DATE: 07.31.2019
TO: ProTrak
FROM: Mitesh Baxi
Traffic Engineering

■ **RENAISSANCE APARTMENTS [TRC Plan Review]**

Initial Review Note

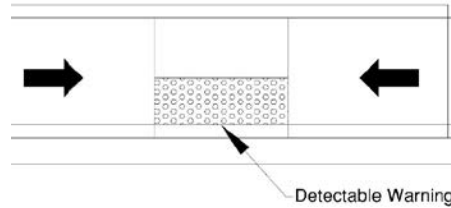
- Revise all relevant sheets to accurately illustrate the existing conditions on and surrounding this parcel. Show all adjacent traffic signs, lane configurations, traffic control devices and pavement markings for Ashes Dr and Fresco Rd roundabout on the plan. Please refer to the Technical Standards and Specifications Manual (link is below) Ch. VII C.1.a.2. for specific information and distance requirements. Contact Traffic Engineering at 341-7888 if you need assistance locating these elements.
<https://www.wilmingtonnc.gov/home/showdocument?id=1910>
- Dimension the existing sidewalk.
